DESCRIPTIVE REPORT

Type of Survey ..... Hydrographic  
Field No. .... RA-10-7-98  
Registry No. .... H-10811

State ..... Alaska  
General Locality ..... Lynn Canal  
Sublocality ..... Chilkat Inlet

# Descriptive Report to Accompany Hydrographic Survey H-10811

Item Investigation #1 ✓

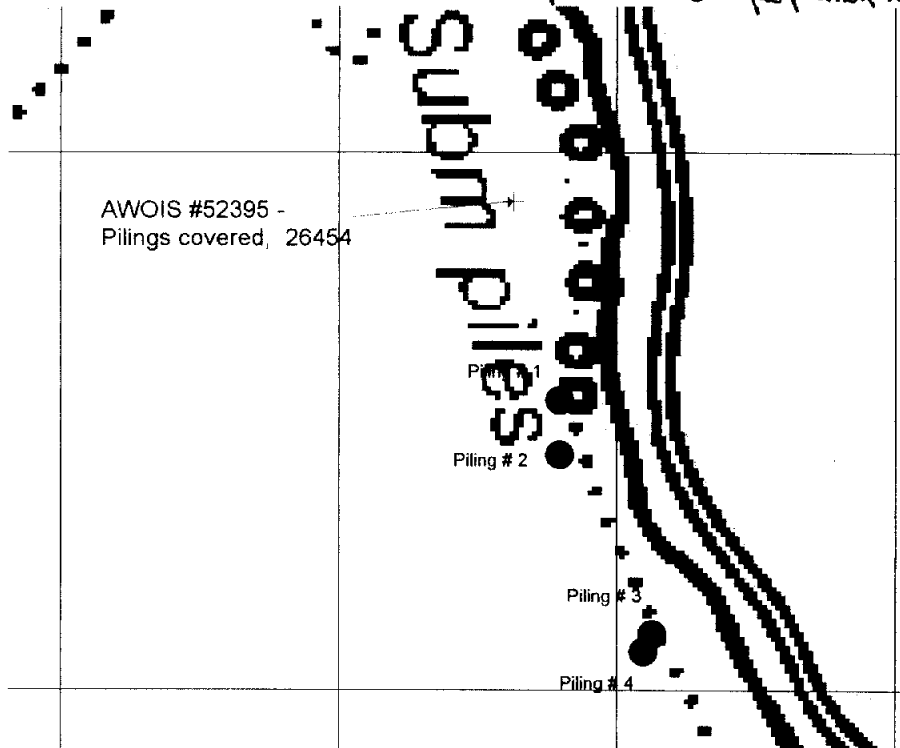
FINDINGS: No pilings were sighted during the visual search from the survey launch. The launch took a detached position from its point of observation (fix 26454, Lat 59-12-57N, Long 135-27-11). Four pilings were found by the wader to be exposed at low water, covered at high water. The pilings were positioned using a handheld non-differential GPS receiver.

The hydrographer recommends removing the seven pilings at the charted positions and charting the four pilings found during this survey. CONCUR

*Pilings were shown on the smooth sheet as portrayed on the hydrographer's detached position and shoreline verification plot. These pilings do have unique position numbers.*

Item Investigation #2 ✓

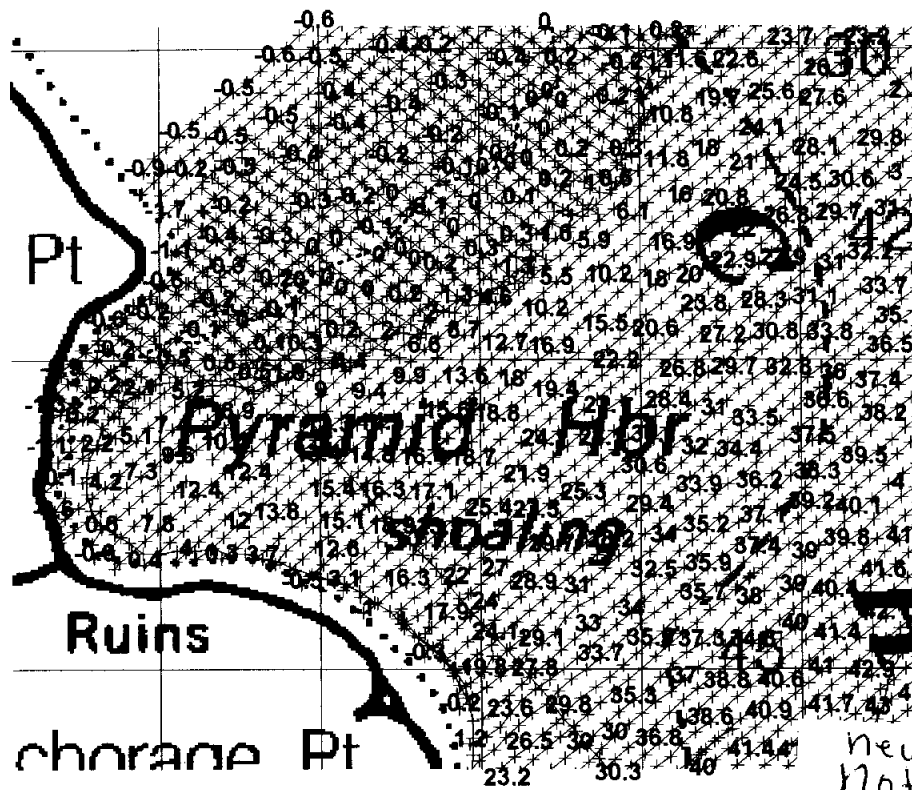
The hydrographer recommends removing the "shoaling" text south of Pyramid Harbor at the charted position and charting the soundings found during this survey. *Concur with clarification, see Eval Rpt. sections M and T.*

*new positions  
not shown  
on H-drawing  
MCR*

Item Investigation #3 ✓

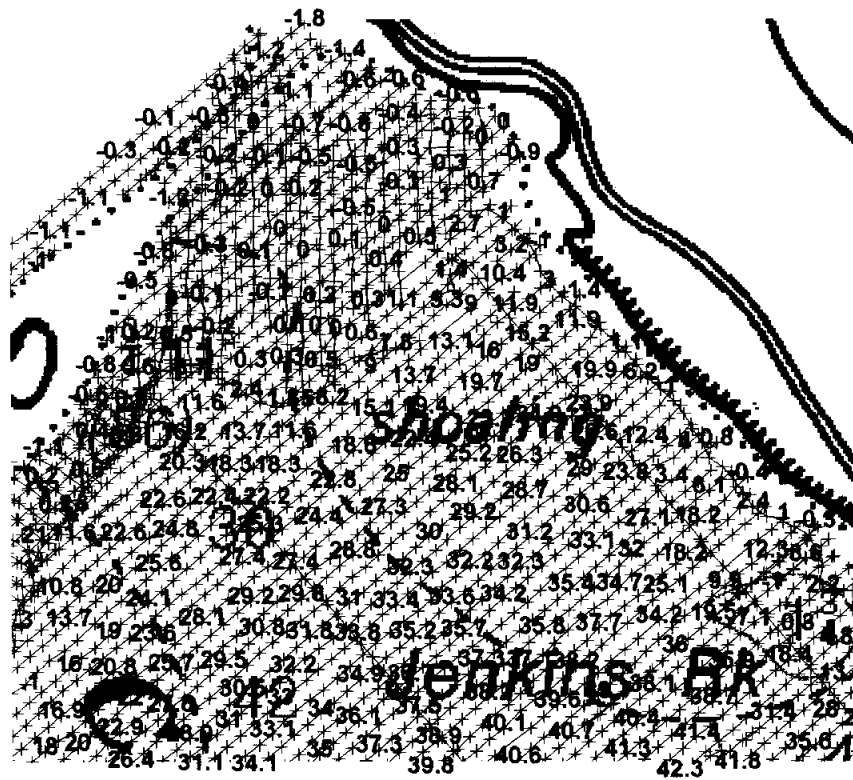
The hydrographer recommends removing the "shoaling" text southeast of Pyramid Island at the charted position and charting the soundings found during this survey. *Concur with clarification. See Eval Rpt, sections M and T.*

Item Investigation #4 ✓

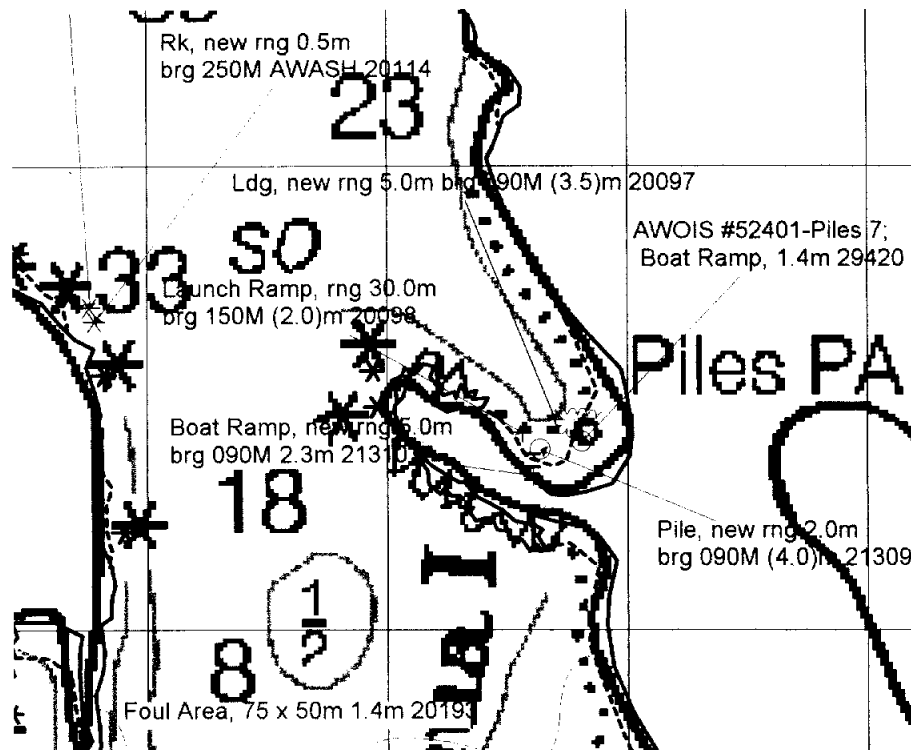
The hydrographer recommends charting the pilings and boat ramp as found during this survey.

*CONCUR with  
Clarification.  
See Encl Rpt. sections  
J and P.*
